RECORDS OF THE GOVERNMENT OF INDIA

PUBLIC WORKS DEPARTMENT.

THE BETWA CANAL PROJECT IN THE NORTH-
WESTERN PROVINCES.

From LIEUT.-COLONEL W. W. H. GREATHED, C.B., R.E., Chief Engineer of Irrigation Works, N.-W. Provinces,
to Inspector General of Irrigation Works—No. 663, dated 18th September 1868.

Ghusgowan Weir—M. Delocre's Profile.

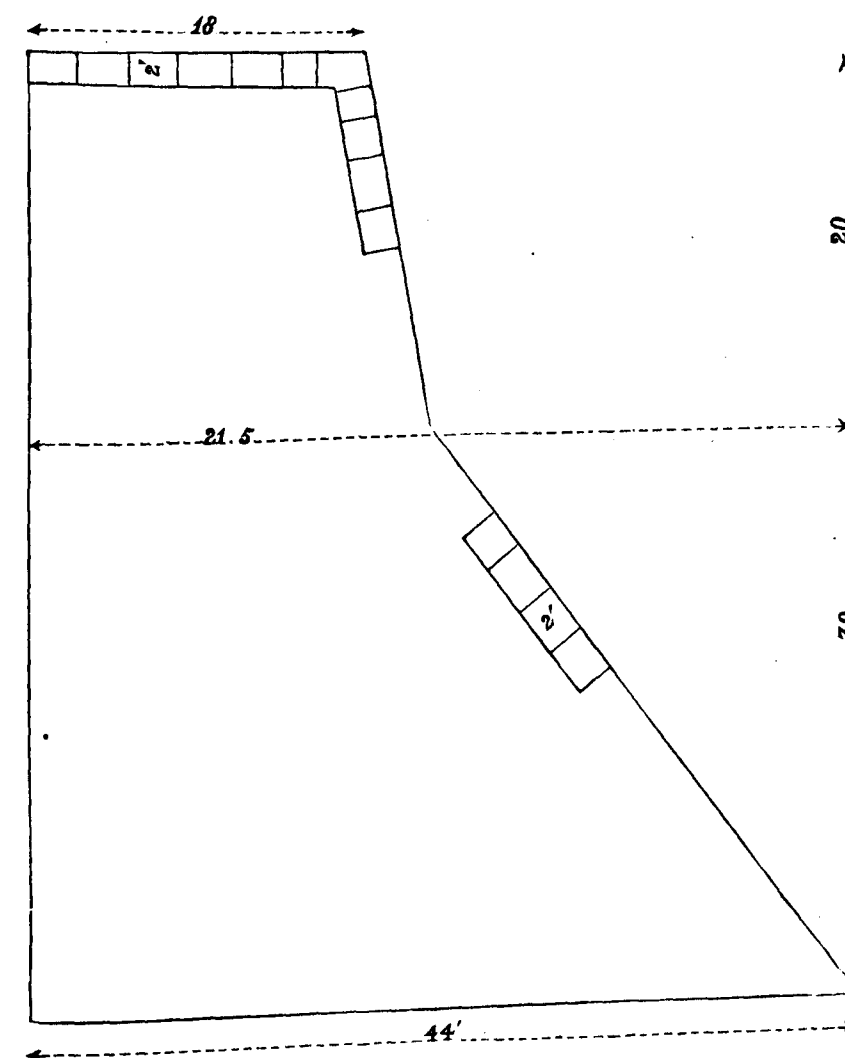
46. *Dam Section*.—In Appendix W, I have given a section of the Khoord dam, modified according to the profile of M. Delocre, and calculated to bear a pressure of 70 feet. In my estimate for this work I have given the same width of ashlar facing as for the Ghugowan weir.

SECTION OF WEIR AT PARICHHA, AS MODIFIED BY CHIEF ENGINEER.

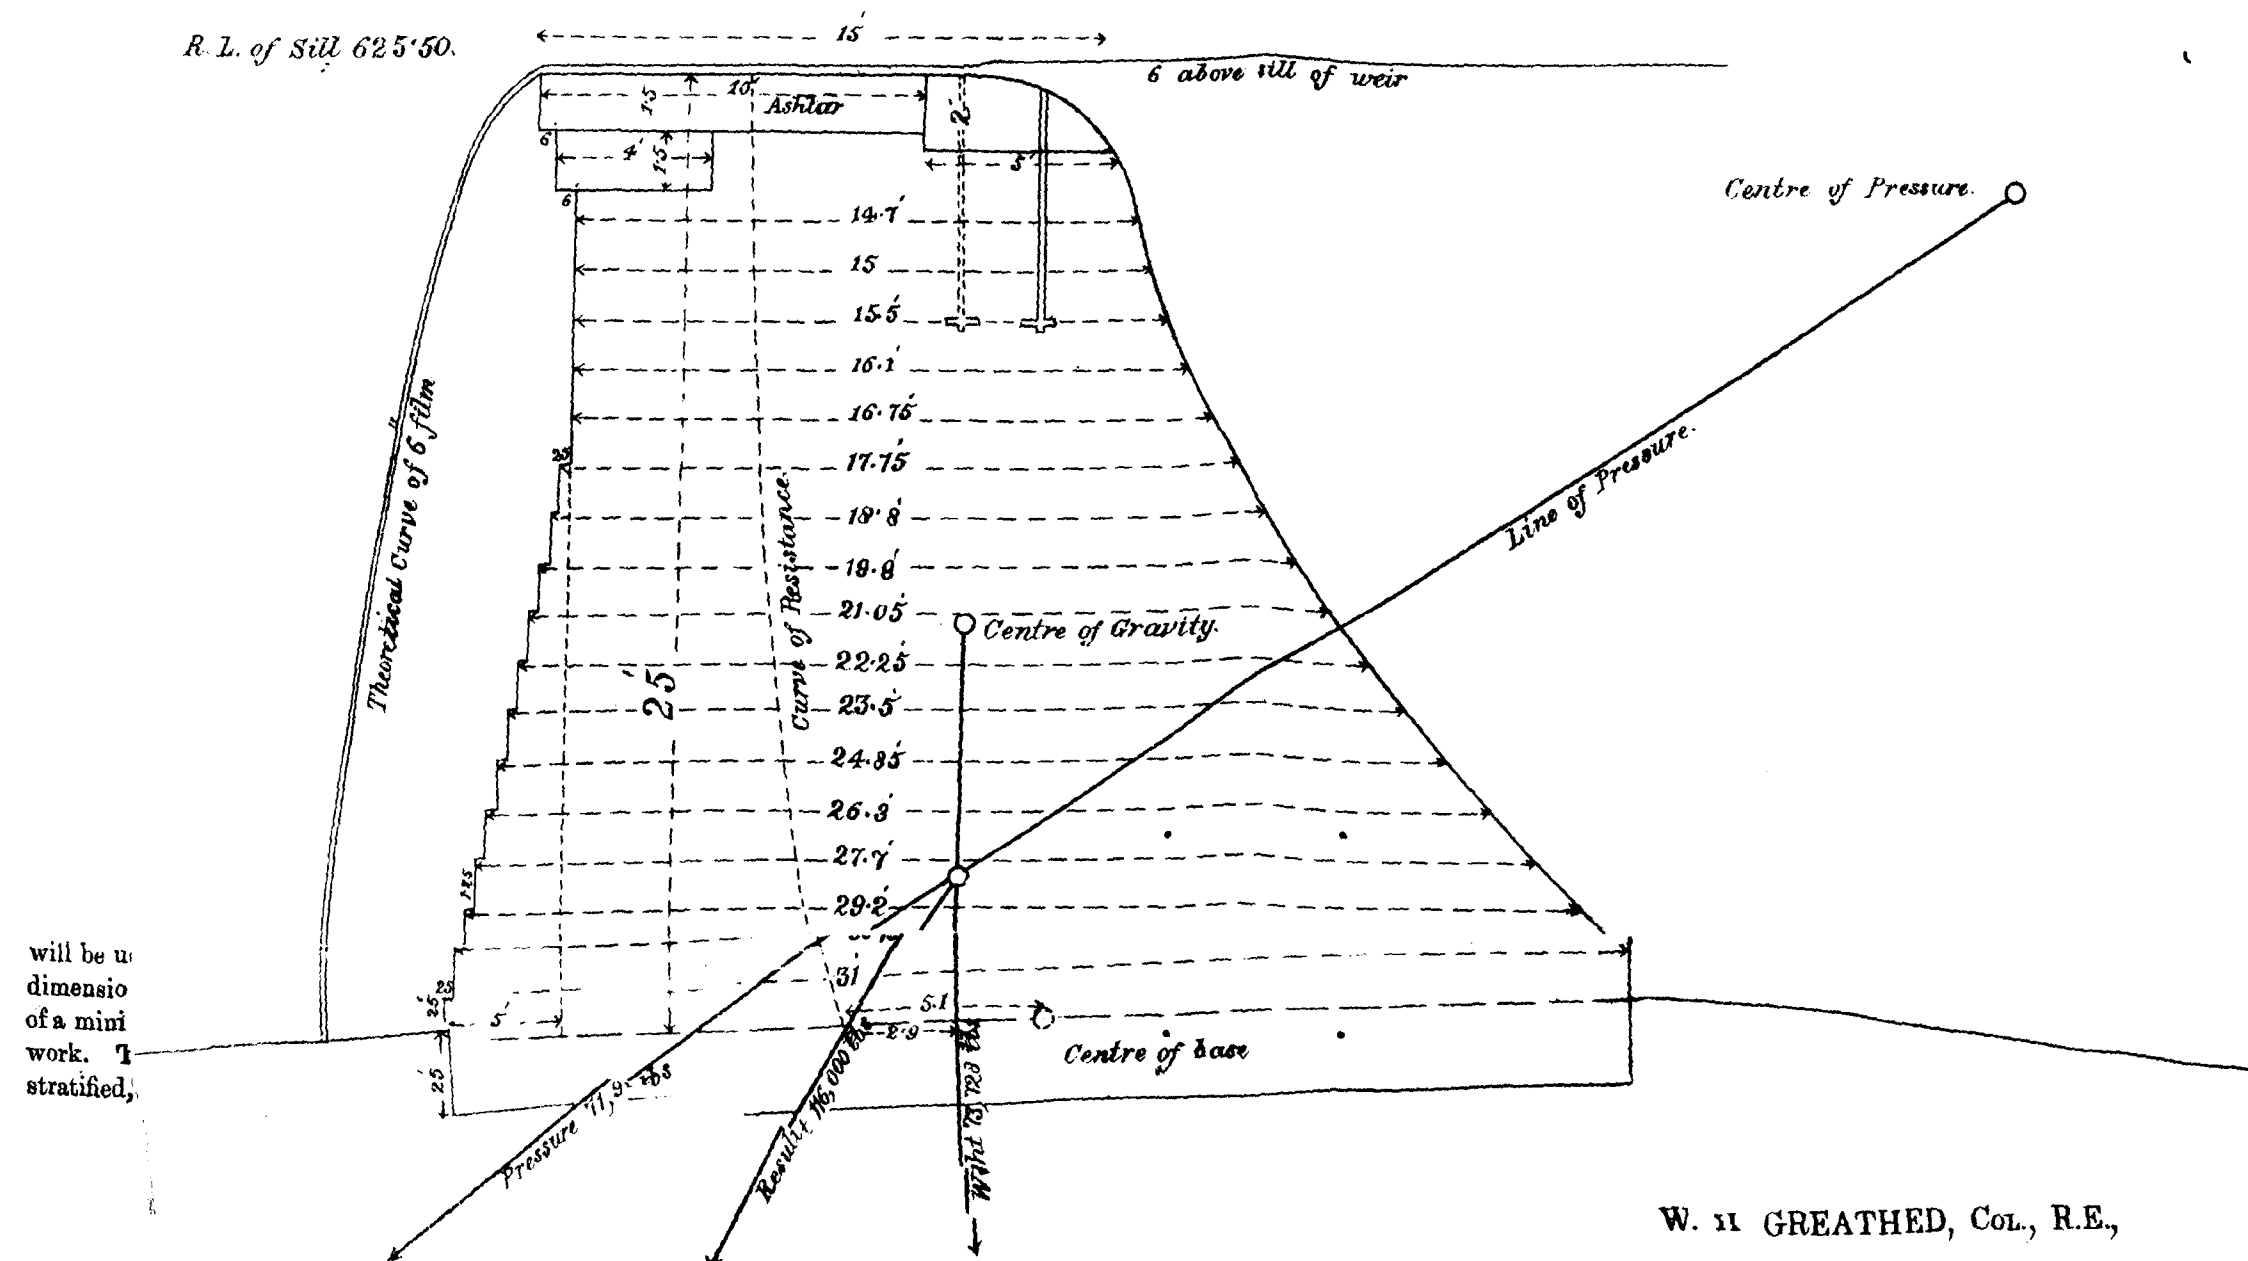
43. I am of opinion that the crest of the weir might be 2·00 lower than that fixed by Captain Bagge, and that this 2·00 could be maintained by planks. I do not anticipate any danger in this plan, and consider Captain Bagge's fears groundless.
